## **SERVICE BULLETIN**

Check of release of the rocket rescue system

Legend 540 and Legend 600

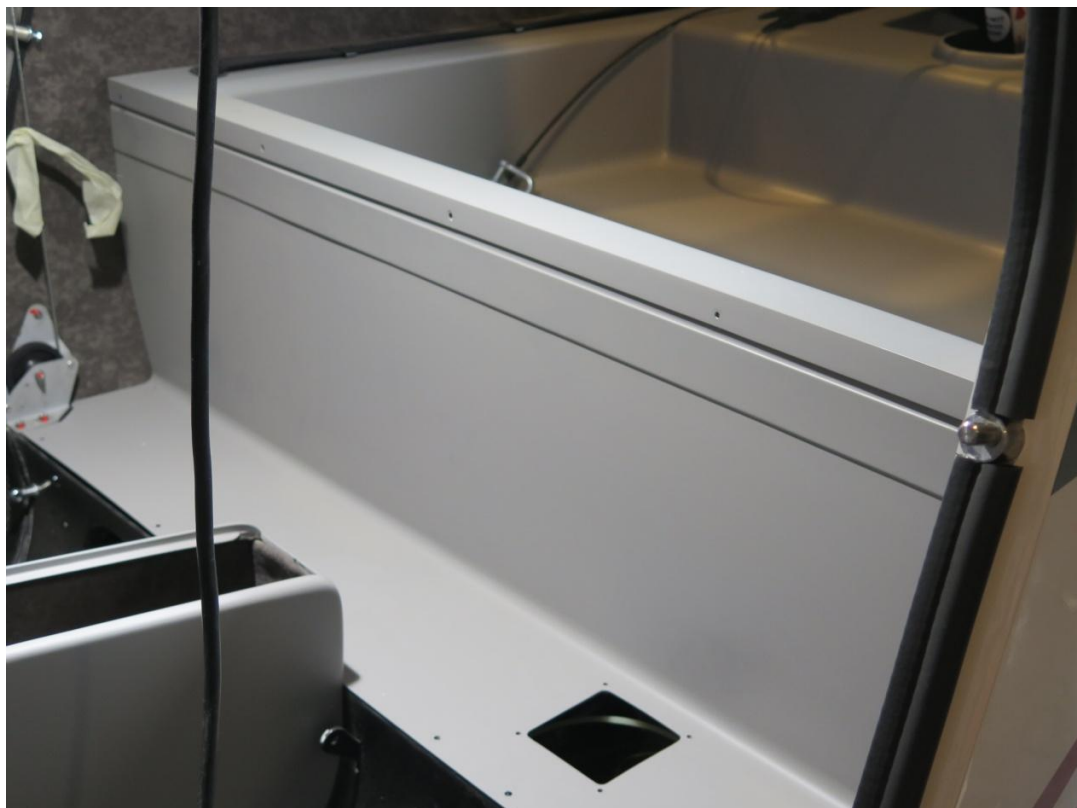
During the revision a gross error in the installation of the parachute rescue system was found, unlocking (unscrewing) the bolt securing the rocket (transport safety), see the attached photo.

- 1) Pull the seat forward and remove it from the fuselage
- 2) Remove the L-shaped laminate cover behind the seats
- 3) Shine inside under the trunk and the locking screw has to be removed in the left side in the flight direction at the bottom of the rocket. At the same time, check that a wire fuse with a red flag is removed at the top of the rocket.
- 4) When both fuses are removed, you can mount the cover and continue to operate the airplane. Otherwise, inform the manufacturer Aeropilot s.r.o., Jeníkovská 1815, Čáslav, Czech Republic. Tel.: +420 605 296 563, info@aeropilotcz.com.

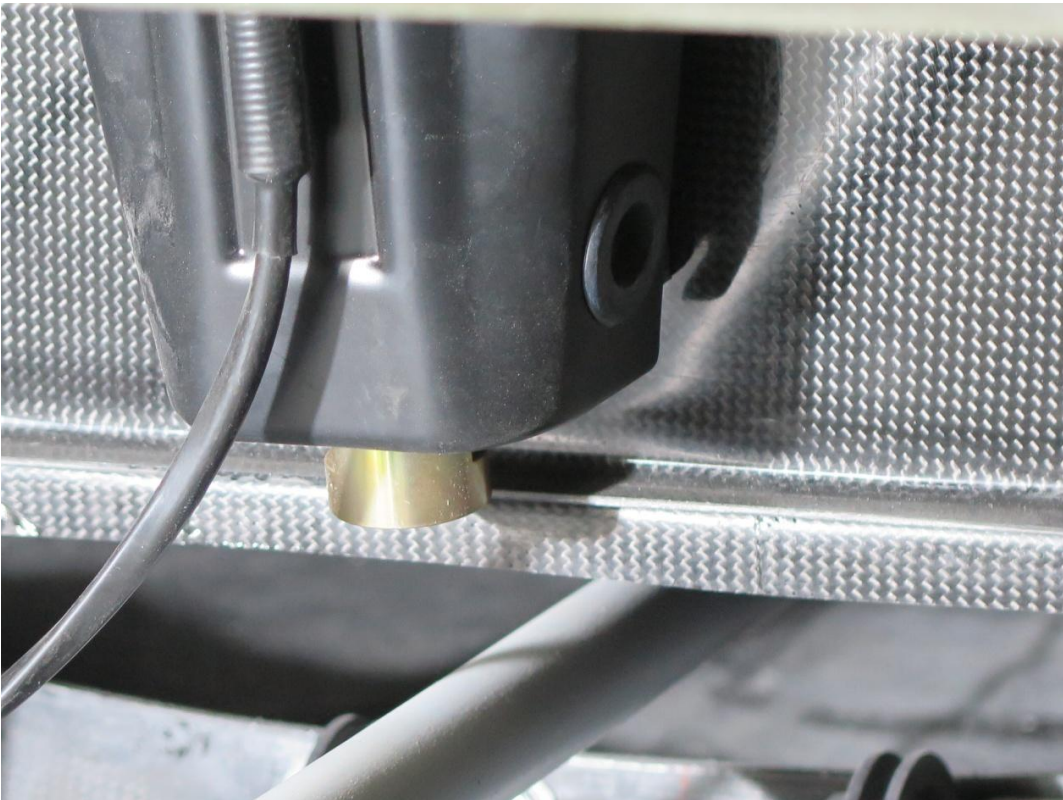
Both fuses have to be removed

Remove the cover

Removed fuse

Removed fuse
